**TOWN OF HERNDON, VIRGINIA
PLANNING COMMISSION PUBLIC HEARING AGENDA
JANUARY 28, 2019
HERNDON COUNCIL CHAMBERS BUILDING
765 LYNN STREET
7:00 P.M.**

Subject: Development Plan #17-01, 555 Herndon Parkway

Title: DEVELOPMENT PLAN - DP #17-01, 555 Herndon Parkway.

OPEN SPACE PLAN

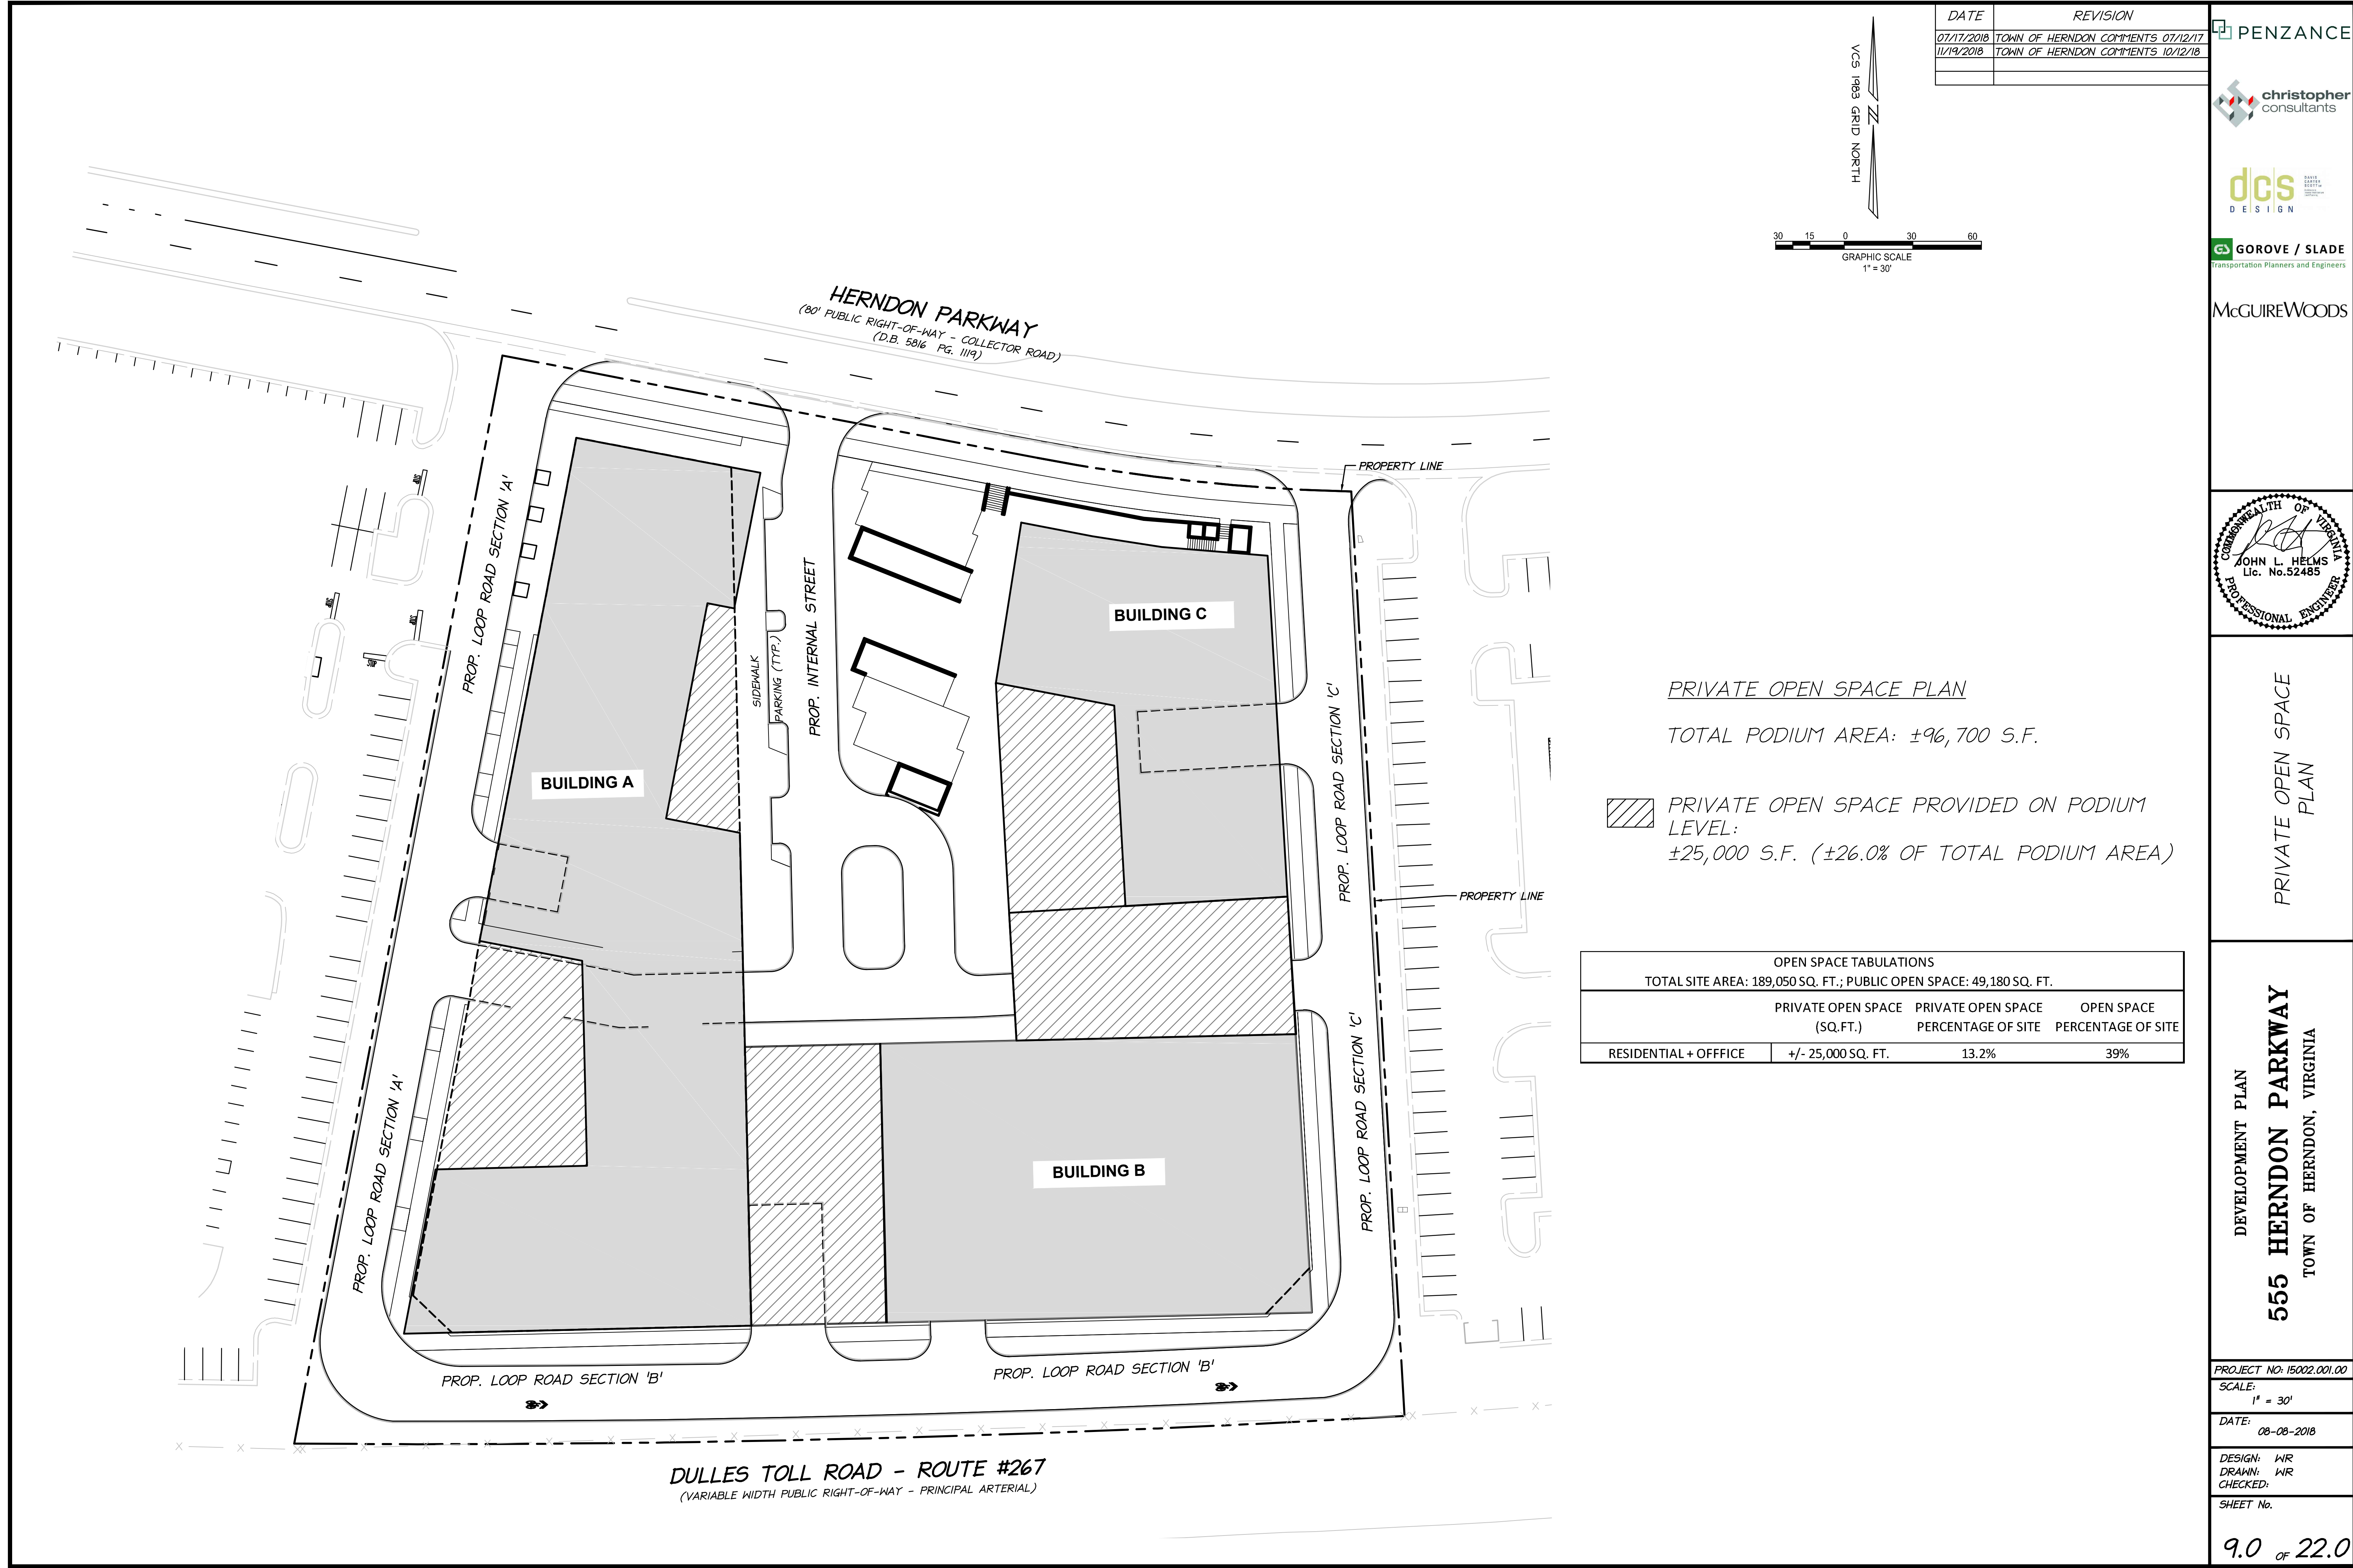
14. The comprehensive plan, HTOC plan, and design guidelines emphasize the need for open spaces with high design and material quality. Section 78-50.8(i) of the zoning ordinance states that open spaces shall be evaluated based on their quality, size, number and diversity of amenities. Required open space, this section further expresses, shall include both passive and active recreation facilities, extensive landscaping, creatively design surfaces, and must strengthen a pedestrian-centric approach to urban design.

To achieve the high quality open space design and materials expected of a plan seeking the maximum density, additional attention is necessary. Staff believes the open space would be improved by:

BUILDINGS SEPARATION

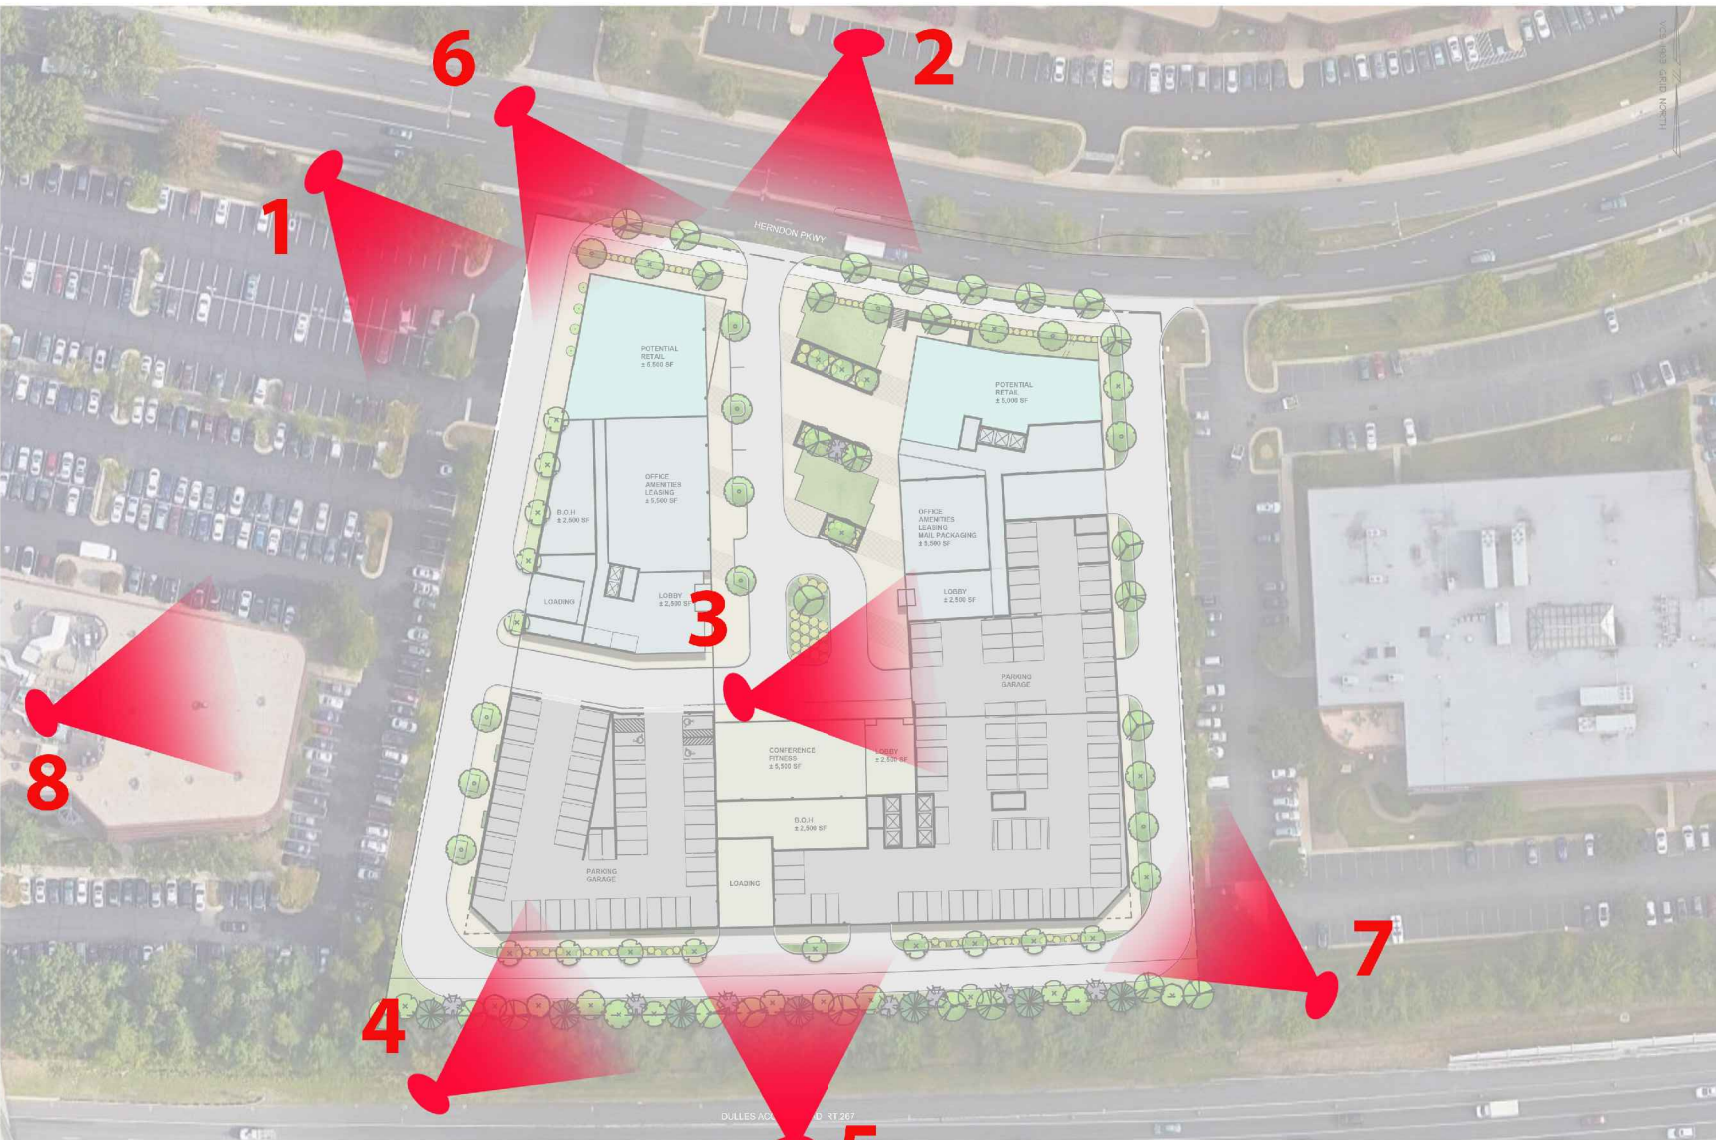
One modification will be necessary with this development plan as proposed. Section 78-50.8(g) of the zoning ordinance requires a minimum building tower separation of 65 feet. This requirement is not met between Buildings A and B and between Buildings B and C. As of the date of this report, the applicant has reference this modification but has not yet submitted a modification request with justification to the Zoning Administrator.

7. A zoning modification to reduce the separation between building towers, as required per Section 78-50.8(g)(4), will be required if this plan, as proposed, moves forward. The formal request for that modification to the Zoning Administrator has not yet occurred. Staff cannot evaluate whether or not that modification is justified without submission of the request.
